<b>Subject:</b>  REAR CONSOLE LID IS LOOSE	<b>Bulletin No:</b> 09-023/15
	<b>Last Issued:</b> 12/14/2015

## BULLETIN NOTE

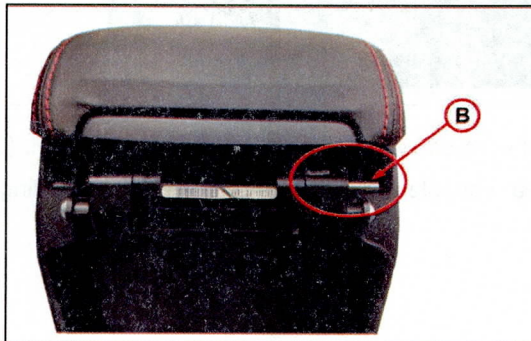
Some customers may complain about a loose rear console lid (A).

This may be caused by hinge pins coming partially off (B) or completely off.

Customers having this concern should have their vehicle repaired using the following repair procedure.

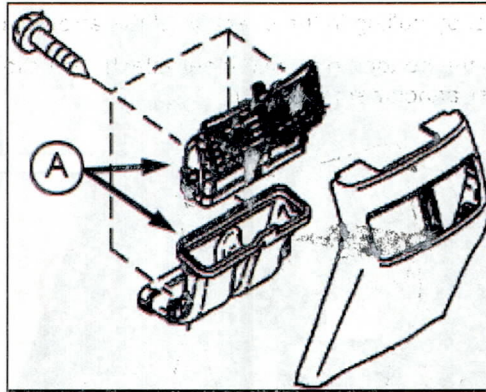
4. **Mazda3 and Mazda6 without ventilation**, install a new rear console panel. (See PART(S) INFORMATION)

**NOTE:** The shape of the rear console panel has been changed, by adding a stopper rib to prevent the pin from coming off.

**Rear Console Panel with Ventilation Repair Information**

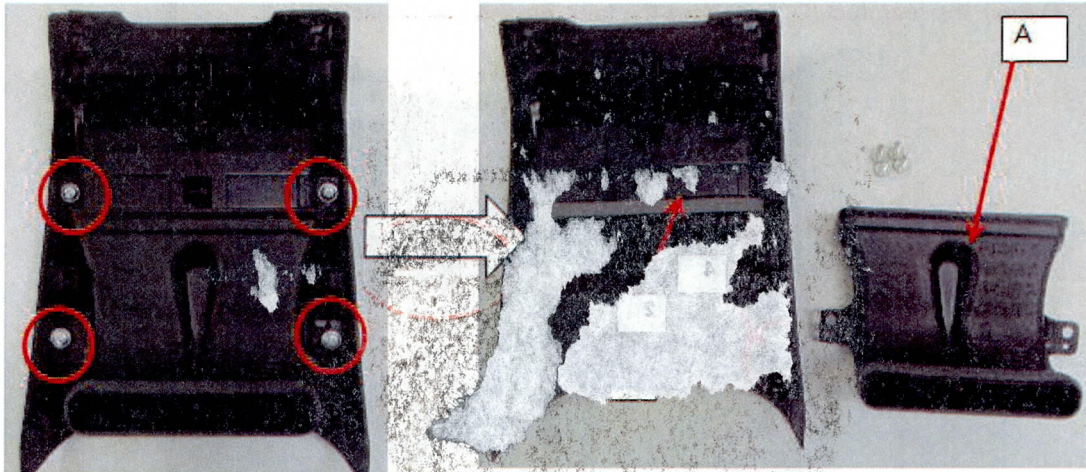
5. Mazda6 with ventilation, install a new rear console panel (see PART(S) INFORMATION) and reuse the rear and front ducts (A).

**NOTE:** The shape of the rear console panel has been changed, by adding a stopper rib to prevent the pin from coming off.
